Observation on a Strategic Infrastructure Development Application

Lemanaghan Wind Farm

Planning Observation – Lemanaghan Wind Farm Application

Proposed 220kV GIS Substation and Associated Grid Infrastructure

LOOKING SOUTH FROM N37T8N2

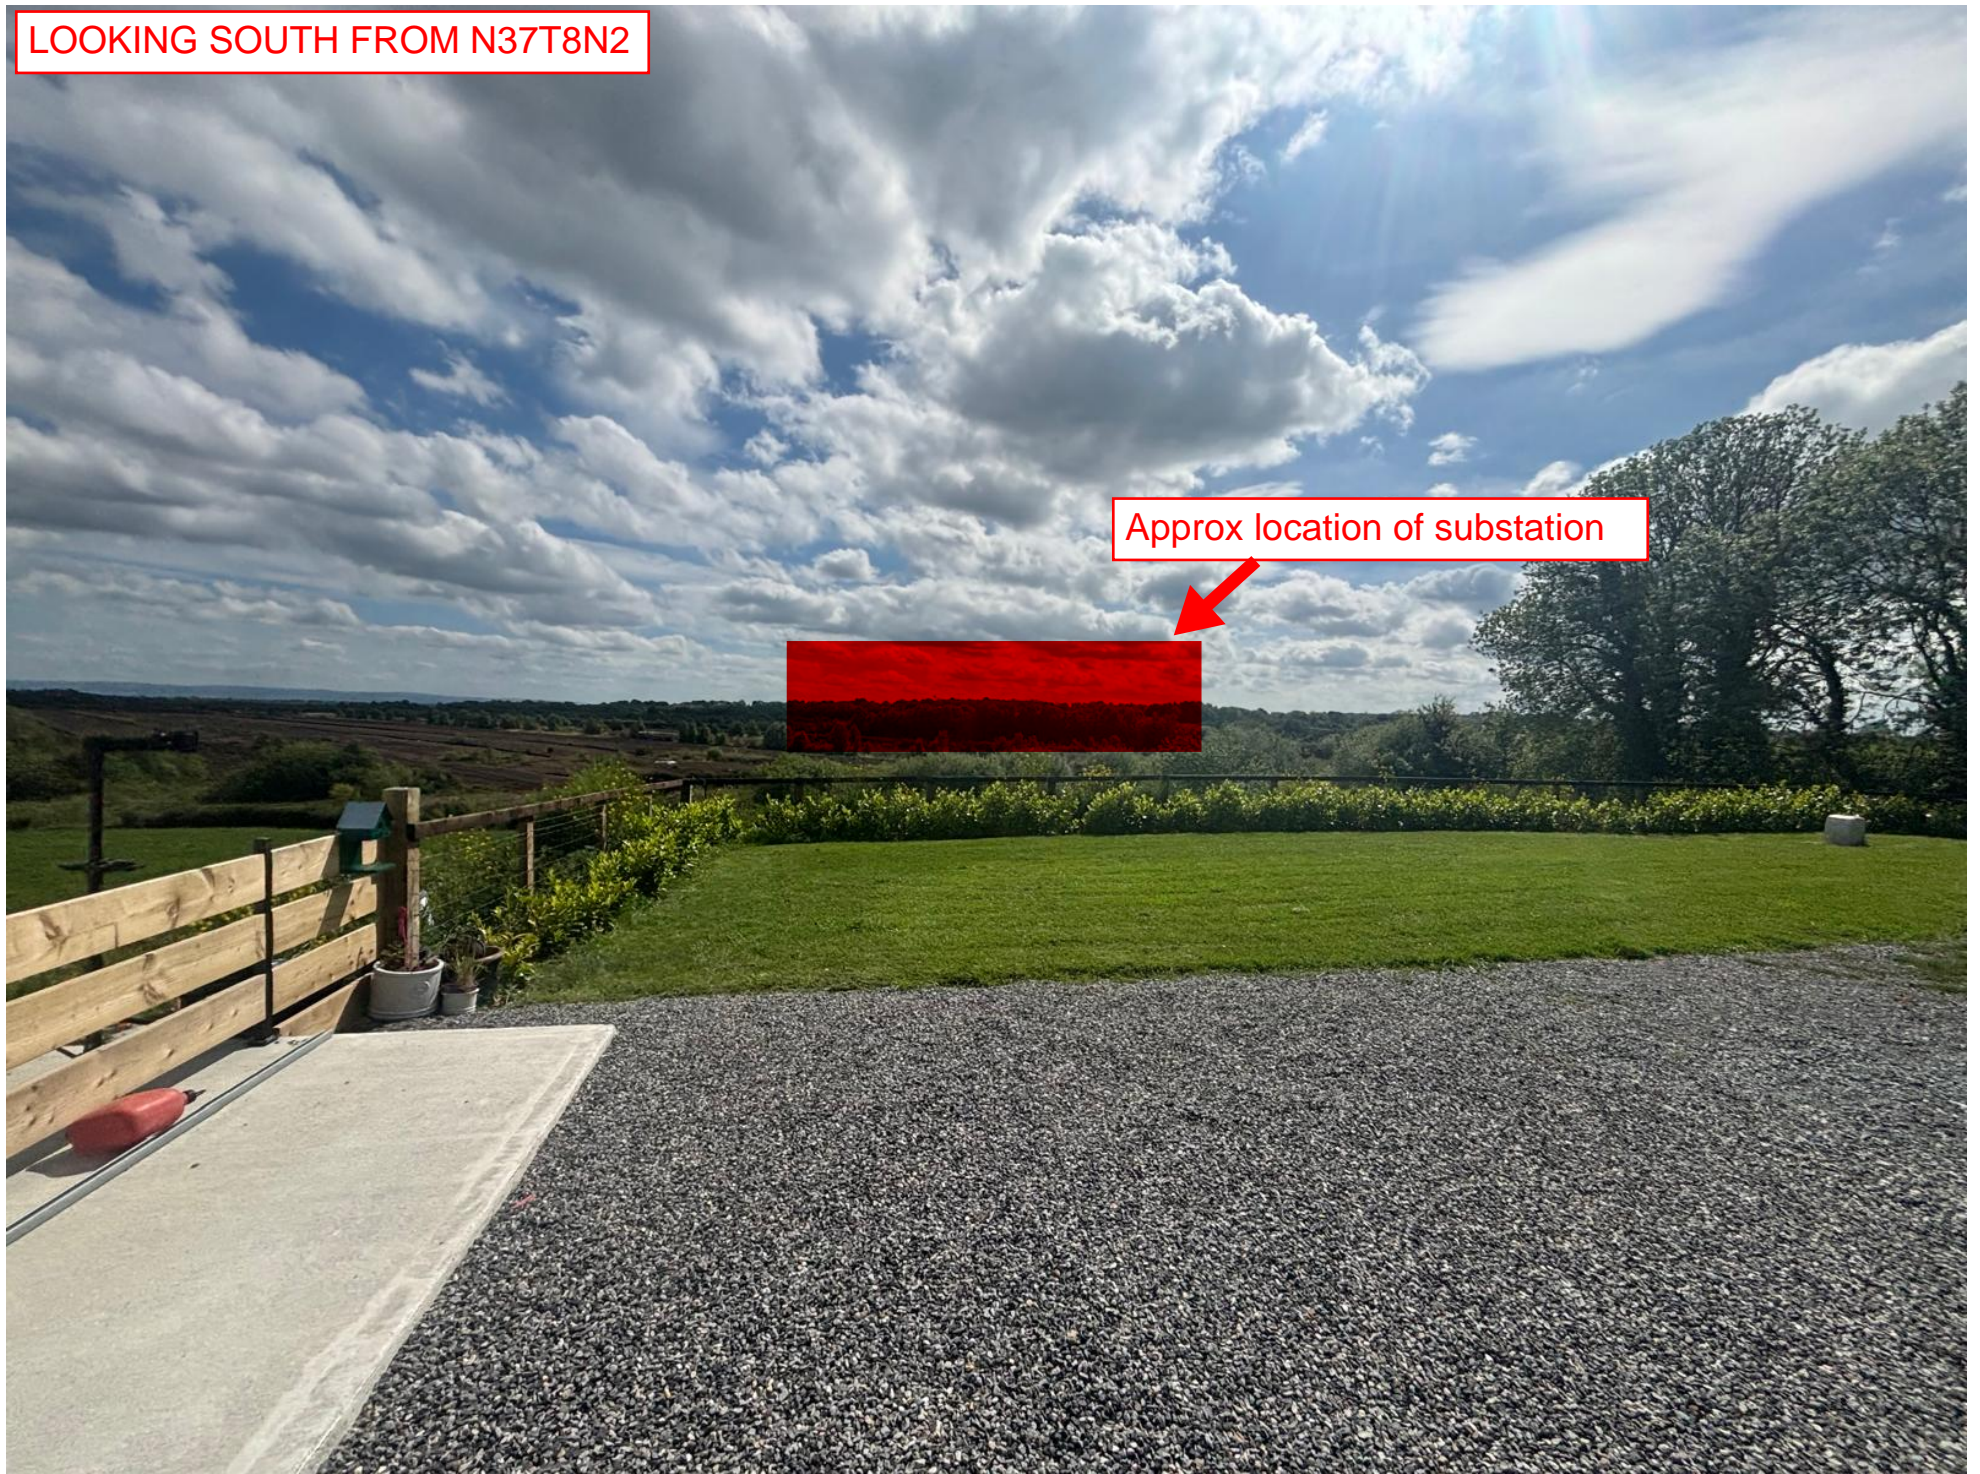
The photographic evidence and annotated drawings submitted with this observation (Appendix C) demonstrate that existing vegetation is either absent, intermittent, immature, or insufficient to materially screen views toward the proposed substation, associated steel structures & telecom tower.

Due to the scale and elevation of the proposed GIS building, the structure would also break the existing horizon line when viewed from nearby residential receptors and sections of the surrounding landscape, introducing visually prominent industrial built form into views currently characterised by open peatland landscapes and distant views toward the townlands of Kilnagarna, Thumbeagh and Rashinagh.
